III. F - VISUAL RESOURCES

Mamaroneck Self Storage Building Addition Final Environmental Impact Statement

III. F. - Visual Resources

Figure
III.F - 2

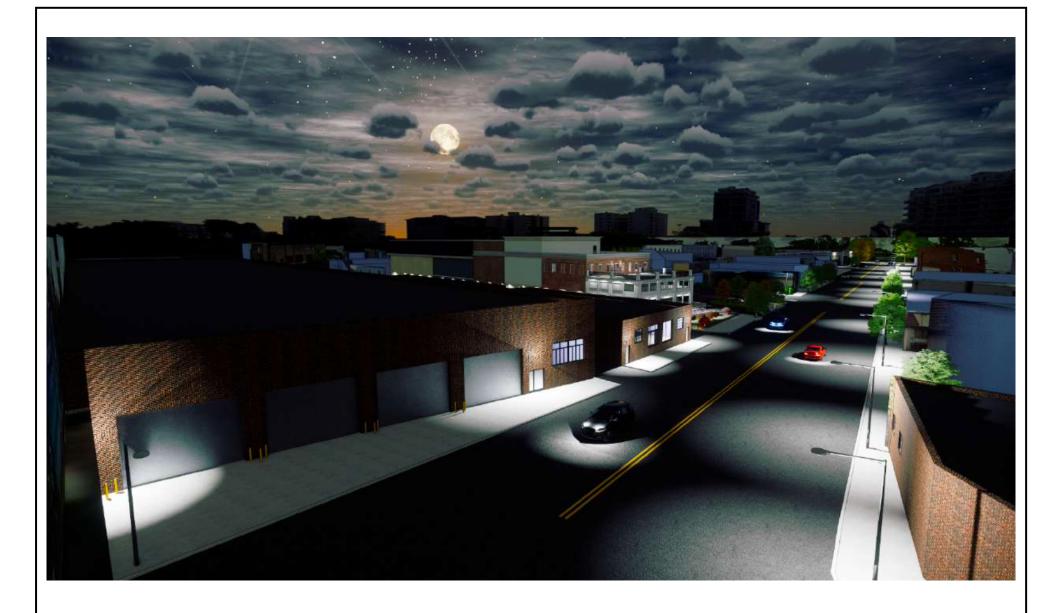
Submit visual renderings of what the site will look like during the day and at night from the train tracks, and I-95.

Refer to Figures III.F-1 – III.F-5
